Final Environmental Assessment for the Molten Chloride Reactor Experiment (MCRE) Project

**August 2023
INL/RPT-22-68976**

Agency and Public Comments Received on the Draft Environmental Assessment and DOE-NE Response

Table A- 1. Comment response matrix.

Figure 10. Earthquakes occurring from 1850 to 2020 with magnitudes greater than 2.0.

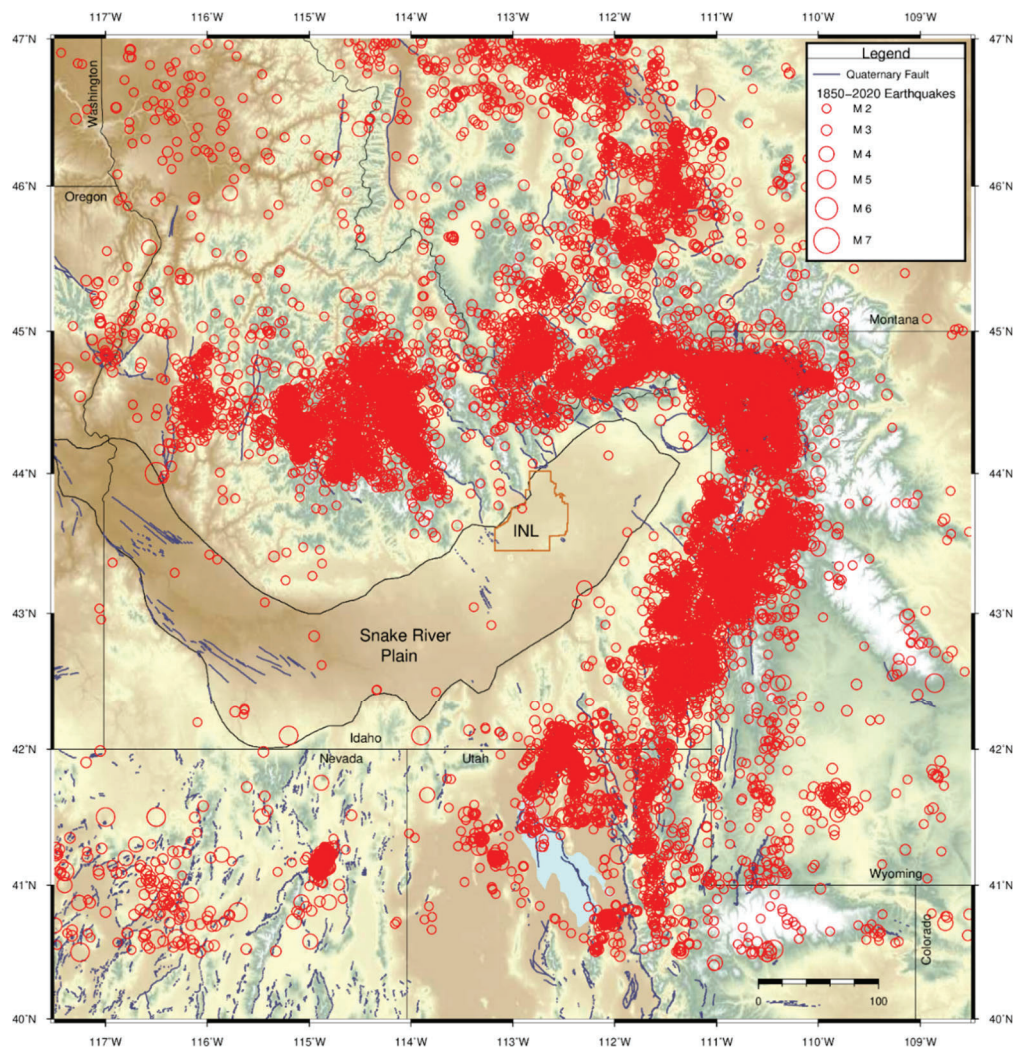
Figure 10, Earthquakes occurring from 1850 to 202 with magnitudes greater than 2.0, shows far fewer earthquakes on the Snake River Plain than the surrounding mountains. It is conveyed that the INL should not be very prone to large seismic events. Despite this, the Idaho National Laboratory is refusing, even for this very small 200-kilowatt reactor, to provide a completed seismic evaluation of the proposed facility that the MCRE will be located in. Nor will the decades of concrete, cable and structural aging be taken into account, likely, if the Department of Energy ever completes a seismic evaluation of the facility at the INL that the experiment will be housed in. The EA simply states that "The evaluation of the ZPPR cell under seismic loads is currently being performed." This is unacceptable and inexcusable. No one has the results of the analysis that is "currently being performed." But, it is "business as usual" for the Idaho National Laboratory and the Department of Energy. Using 150 years of seismic experience is inadequate to conclude that no impacts due to seismic events would occur and DOE knows better.
